Item ID: DSI 9579-011

Item Name: Composite Door Upgrade

DART SERVICE INSTRUCTION

TO AMEND INSTALLATION INSTRUCTIONS IIN-D206-802-3 Rev. A AND
INSTRUCTIONS FOR CONTINUED AIRWORTHINESS ICA-D407-802 REV. 0

FIGURE 1: INSTALLATION OF D206-802-032 ON COMPOSITE AIRFRAME

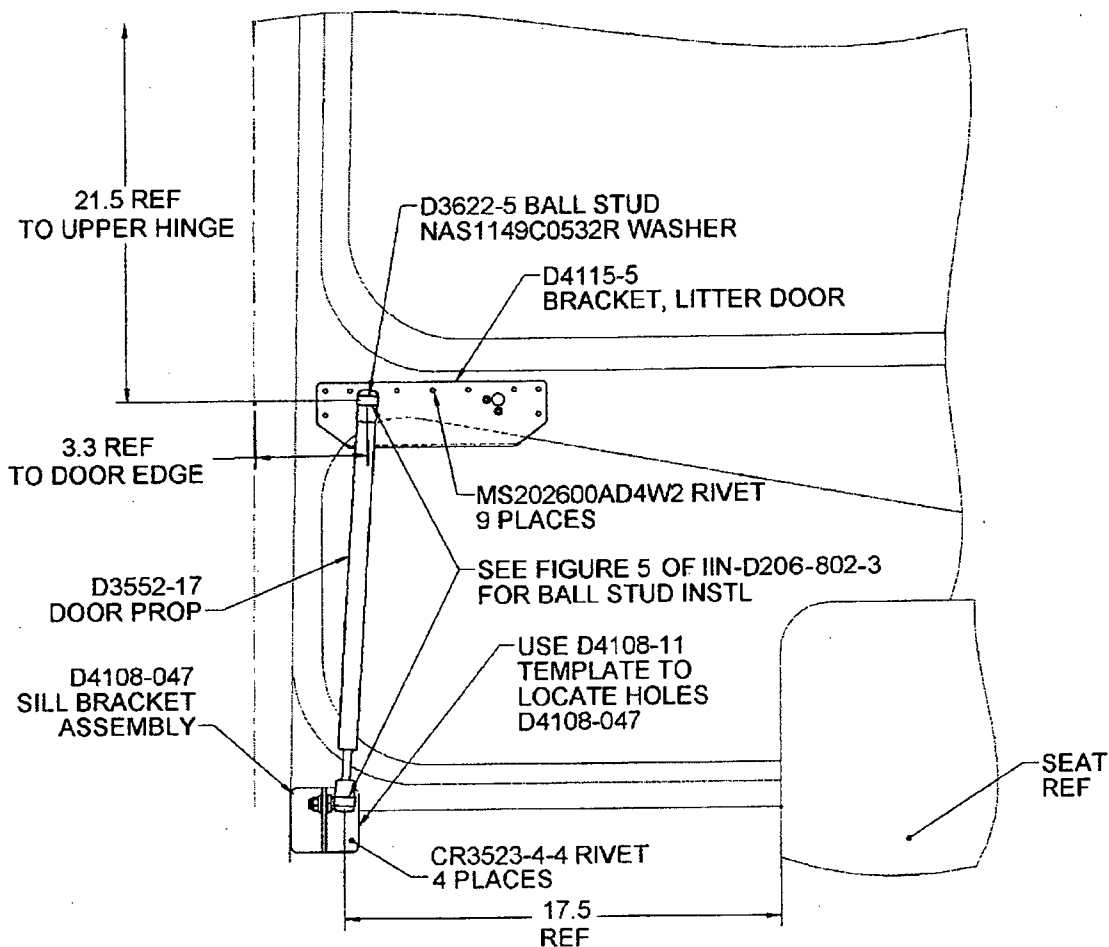
4.2 On composite airframe:

Install D206-802-032 by replacing D4112-1 Aft Sill Doubler with D4108-047 per instructions below and Figure 1 of this Service Instruction.

- a) Using Figure 1 of this Service Instruction, locate D4108-11 Template on the edge of the door post closeout approximately 17.5" from the front of the seat. Match drill the Ø0.128" rivet holes (4 PL) on the door sill. Locate and drill thru template and door sill if the door sill is without existing holes.

- b) Transfer drill the Ø0.128" holes (4 PL) from D4108-11 Template to the D4108-047 Sill Bracket Assembly.
- c) Deburr all drilled holes and clean area.

- d) Remove and retain the Ball Stud and hardware from the D4108-047 Sill Bracket Assembly.
- e) Install D4108-047 Sill Bracket Assembly by applying a thin layer of Proseal 890 and wet installing the CR3523-4-4 Rivets (4 PL) as shown in Figure 1 of this Service Instruction.

- f) Remove excess Proseal, grind rivet stems flush and clean area of any debris.
- g) Re-install the Ball Stud and hardware removed at Step "d)" of this instruction.

- h) Re-position the carpet and interior trim panel. Trim/cut as required for the ball stud and to allow the D4108-047 Sill Bracket Assembly to protrude.

- i) Re-install the scuff plate.
- j) Install rod end of D3552-17 Door Prop onto the Ball Stud mounted on D4108-047 Sill Bracket Assembly.
